MARK	DATE	DESCRIPTIONS	BY	CH'D	CCO#
3	07/30/10	SEISMIC JOINT MODIFICATIONS HINGE A	CR	MN	25
2	04/09/10	HINGE A MODIFICATIONS	MN	NV	120
1	11/06/06	PER CALTRANS SEISMIC JOINT MODIFICATION	MN	AS	25

SAN FRANCISCO OAKLAND BAY BRIDGE
EAST SPAN SEISMIC SAFETY PROJECT
SELF-ANCHORED SUSPENSION BRIDGE
(SUPERSTRUCTURE & TOWER)

HINGE A DETAILS NO. 1

SECTION A-A
(Orientation of Expansion Joint shown for Eastbound, see Note 10)
1:40

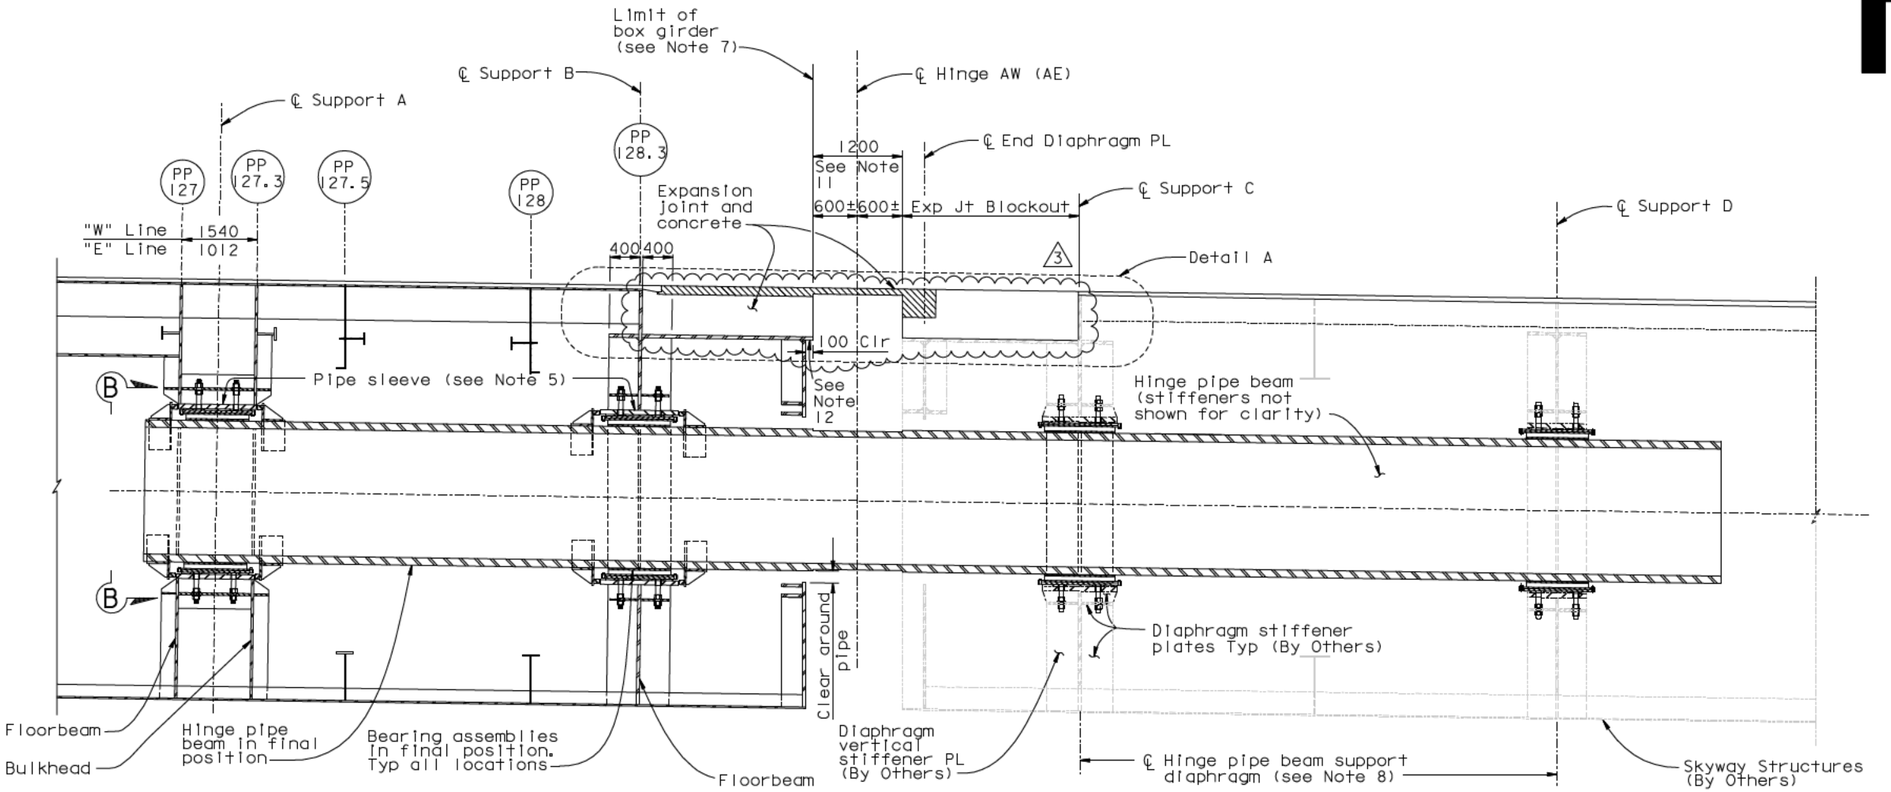
10. For orientation of expansion joints, see "Hinge A Expansion Joint Details" plans. (3)
11. The as-built gap at Hinge A shall be 1200 minimum. The limit of the concrete blockout shall be adjusted based on the field conditions of the Skyway.

12. The Contractor shall trim the blockout end PL and blockout bottom PL to maintain an expansion gap of 1200 minimum.
